MFN 09-427

Subject: Response to Portion of NRC Request for Additional Information Letter No. 337 Related to ESBWR Design Certification Application - Auxiliary Systems - RAI Number 9.1-50 S03

**Response to Portion of NRC Request for
Additional Information Letter No. 337
Related to ESBWR Design Certification Application
Auxiliary Systems
RAI Number 9.1-50 S03
Sketch**

Fuel Handling Sketch

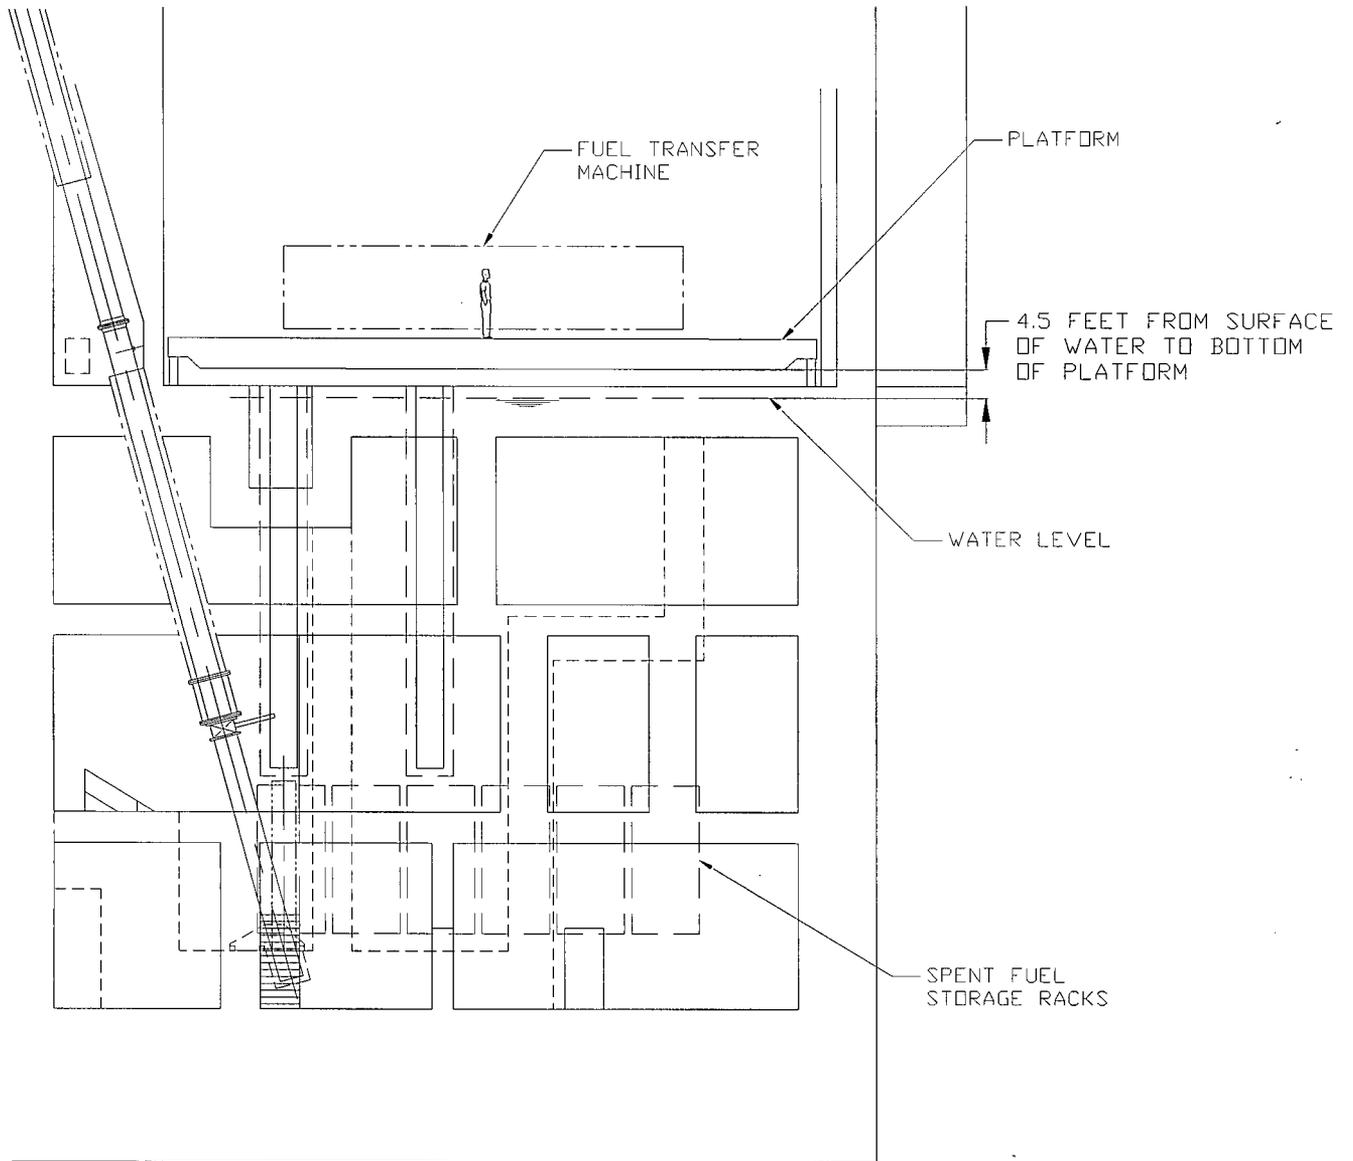
1. Table 4 of the calculation presents dose rates at the spent fuel pool water's surface and at [[]] above the water from a single fuel assembly located [[]] below the water's surface. It is not clear how the heights of [[]] above the water surface of the spent fuel pool (SFP) correspond to the location of a person standing on the fuel handling bridge deck during refueling operations in the Fuel building. Provide a drawing showing the configuration of the spent fuel pool, fuel handling elevation, and refueling personnel located on the fuel handling machine.

1. A sketch is provided in the attached markup that shows the configuration of the spent fuel pool, fuel handling elevation and refueling person located on the fuel handling machine platform.
